Access Compliance Report

Public Rights-of-Way

(Curb Ramps)

Intersection ID: 18337	Main Street: SELWYN_AV	Cross Street: RUNNYMEDE_LN	Location: NE
ADA ID: 1F39C25E4D36	Ramp Type: Perp	Initial Pass/Fail: Fail	Overall Compliance: No
		Severity Score: 10

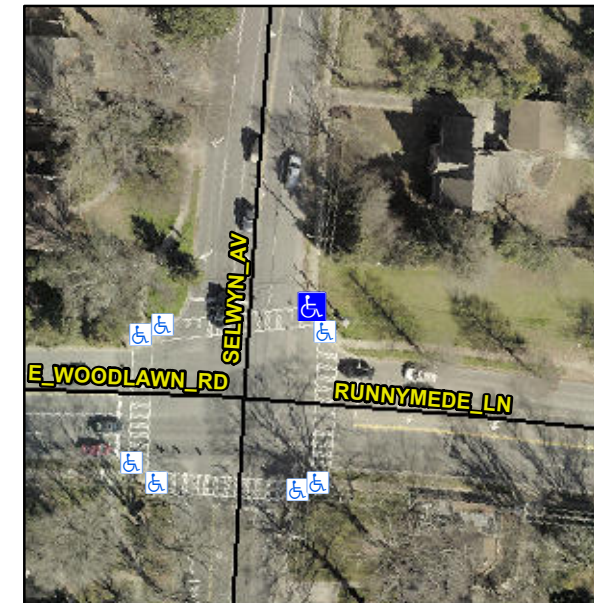
Not Found, R304.5.1, R304.5.3

Compliance	Description	Data	Compliance	Description	Data
N/A	Ramp Length (in)	48.0	Yes	Ramp Slope (%)	5.2
No	Ramp Width (in)	43.5	No	Ramp XSlope (%)	3.7
N/A	Flare Type LT	N/A	N/A	Flare Type RT	N/A
N/A	Flare Slope LT (%)	N/A	N/A	Flare Slope RT (%)	N/A
N/A	Flare Traversable LT?	N/A	N/A	Flare Traversable RT?	N/A
N/A	Landing Length (in)	N/A	N/A	DWS Provided?	N/A
N/A	Landing Width (in)	N/A	N/A	DWS Contrast?	N/A
N/A	Landing Slope (%)	N/A	N/A	DWS Length (in)	N/A
N/A	Landing X Slope (%)	N/A	N/A	DWS Full Width?	N/A
N/A	Landing Curb? (Y/N)	N/A	N/A	DWS Offset (in)	N/A
N/A	Shared Landing?	N/A			
N/A	Gutter Ponding?	N/A	N/A	Gutter Slope (%)	N/A
N/A	Gutter Lip Ht (in)	N/A	N/A	Gutter X Slope (%)	N/A
N/A	Painted X Walk1?	Yes	N/A	Painted X Walk2?	N/A
	X Walk 1 Direction	To W		X Walk 2 Direction	N/A
N/A	X Walk 1 Width (in)	112.0	N/A	X Walk 2 Width (in)	N/A
	X Walk 1 Slope (%)	2.5		X Walk 2 Slope (%)	N/A
	X Walk 1 X Slope (%)	0.3		X Walk 2 X Slope (%)	N/A

Remove & Replace Entire Ramp.
